energy center

Sufficiency Responses

From: Barbara_P_Linkiewicz@fpl.com
Sent: Tuesday, June 07, 2005 5:12 PM
To: Kosky, Ken
Cc: Rachel_Godino@fpl.com; John_Gnecco@fpl.com
Subject: West County Energy Center - DEP SED comments

Figure 4.
Upper Floridan Aquifer Production Well
Construction Details (Typical)
FPL West County Energy Center, Palm Beach County, Florida
Source: Golder, 2005.

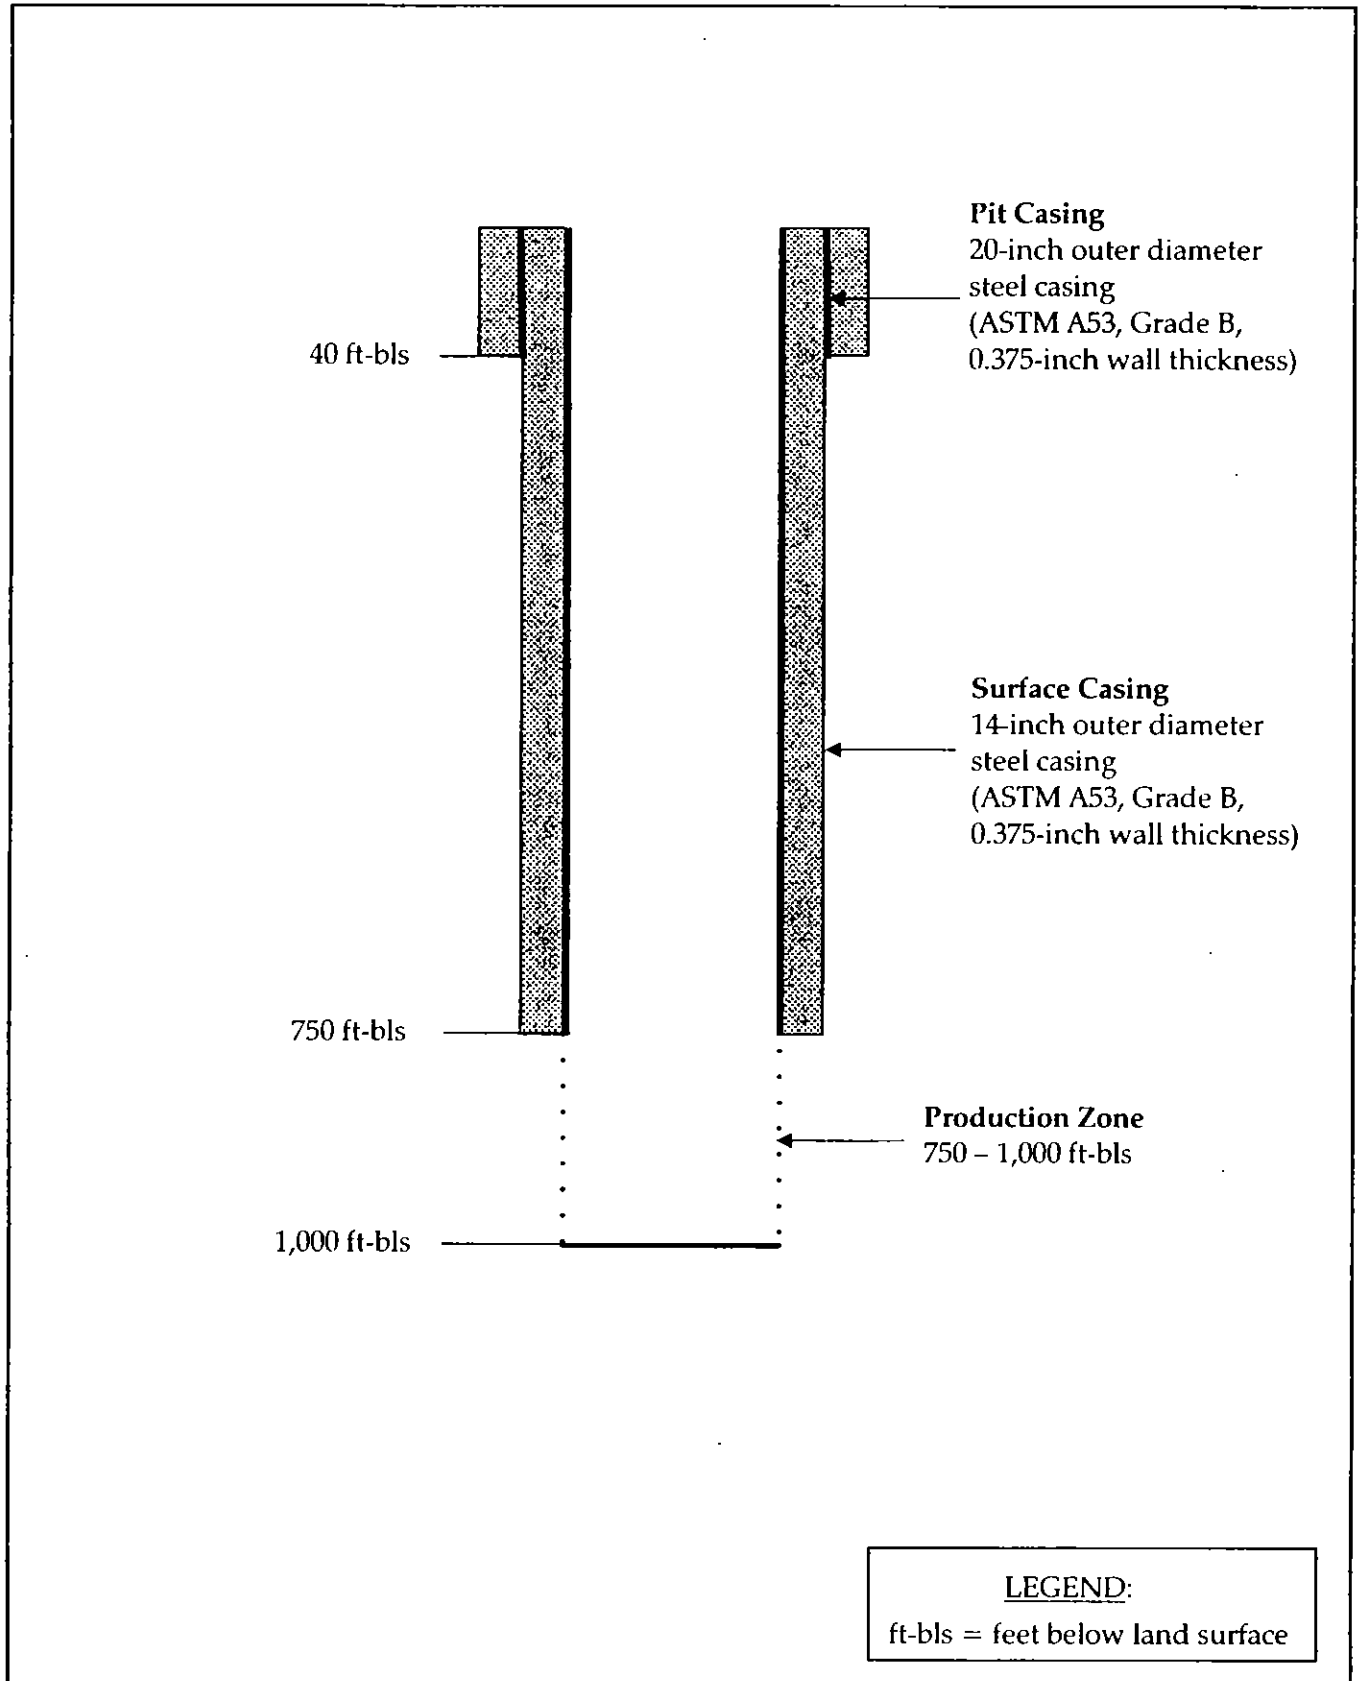
modeling to determine impacts of the emergency withdrawals was done for the UFA, between 750 and 1350 feet bls and for LFA PZ-1 between 1500 and 1650 bls. The site map for the facility (Chapter 3, Sheet 3) does not show any UFA well sites. The proposed UFA wells are not described in the construction details, which only describe the drilling and testing of the Deep Injection Wells (Section 4.1.5) and exploratory well (Appendix 10.1.8). Please clarify and revise, as necessary.

Response 22: The exploratory well will be converted to a dual-zone monitoring well to provide monitoring for the northern most DIW. Other monitoring wells are proposed for subsequent DIWs and identified as I.D. Number 34, Monitor Wells, as shown on Figure 3.2.0-4 of the SCA.

Upper Floridan Aquifer (UFA) wells are identified in Chapter 3, Figure 3.2.0-4, Plot Plan. These are I.D Number 31, Groundwater Wells, Backup Production Wells. The most northerly UFA well is located just south of I.D. Number 35, Exploratory/Dual Zone Monitoring Well (immediately south of the large stormwater pond-I.D. Number 27), adjacent to the proposed I.D. Number 19, Underground Injection Well(s), 1-unit capacity. Another Groundwater Backup Production Well is located approximately 2,000 ft due south.
